PRODUCT CHANGE NOTIFICATION (PCN)

A-MCSP-80010
MODULAR CABLE

CHANGE NOTIFICATION: PCN 20220425_A-MCSP-80010

DESCRIPTION OF CHANGES:
CHANGE OF DATA SHEET
CHANGE OF DATA SHEET
New Draw.-No. ASS_7425_CArev07

A-MCSP-80010 OLD VERSION

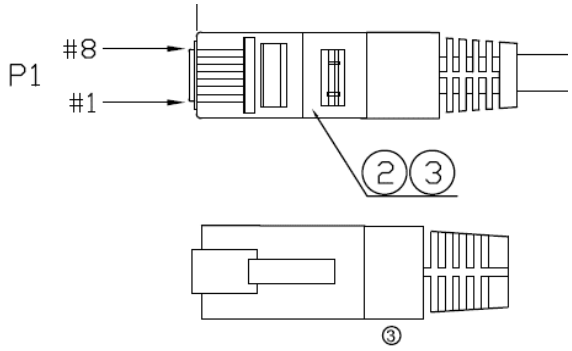
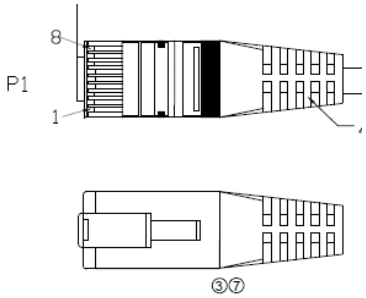
REASON FOR CHANGE:
CHANGE OF PRODUCT LOCATION
CHANGE OF PRODUCT LOCATION

NO	PART NO	DESCRIPTION	QTY	UNIT
	3	mold	PVC,50P	9,0	G
	2	plug	8P8C plating gold 3U" with metal shield	2	PCS
⑤	1	cable	FTP (26AWG*1P)*4+D+A+PVC, OD:5.2±0.2mm CAT5E	2.0	M

NO	PART NO	DESCRIPTION	QTY	UNIT
⑦	4	AL-Foil	Double-sided conductive aluminum foil	2	PCS
⑦	3	mold	PVC,65P	AR	G
	2	plug	8P8C plating gold 3U" with metal shield	2	PCS
⑦⑤	1	cable	CAT5E F/UTP (26AWG*1P)*4+D+A+PVC, OD:5.2±0.2mm	AR	M

Drawing-No.
ASS 7425 CA

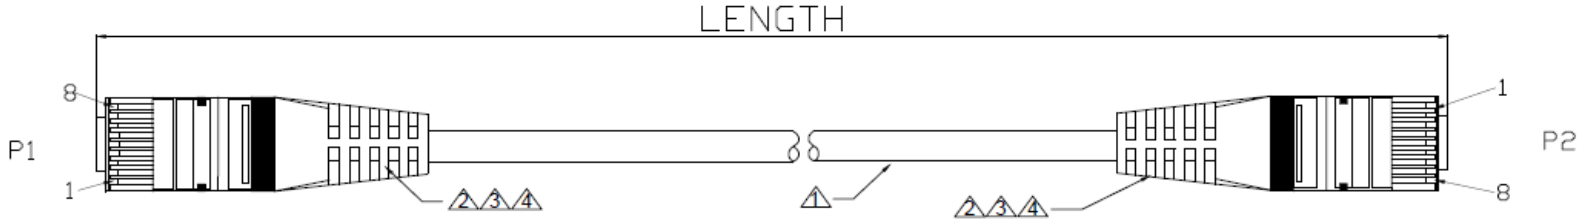
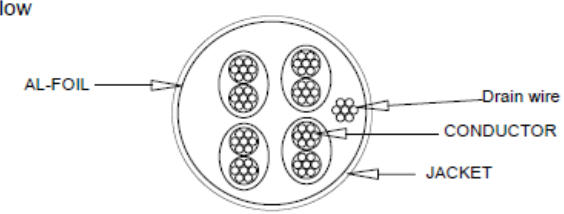
Id.	Modification	Date	Name		Date	Name
⑦	Change the plant	12.04.2022	Luca			
⑥	Clarify the tolerance	23.08.2018	Segal	Drawn	26.06.2015	Joanna
⑤	Add "CAT5E"	20.10.2017	Stephon	Approved	12.04.2022	Luca
④	Add length for 20M and 30M	20.09.2017	Fred			
③	remove mark on the mould	29.06.2016	Joanna			
②	Add length for 300mm	18.05.2015	Joanna

NO	PART NO	DESCRIPTION	QTY	UNIT
⑦	4	AL-Foil	Double-sided conductive aluminum foil	2	PCS
⑦	3	mold	PVC,65P	AR	G
	2	plug	8P8C plating gold 3U" with metal shield	2	PCS
⑦⑤	1	cable	CAT5E F/UTP (26AWG*1P)*4+D+A+PVC, OD:5.2±0.2mm	AR	M
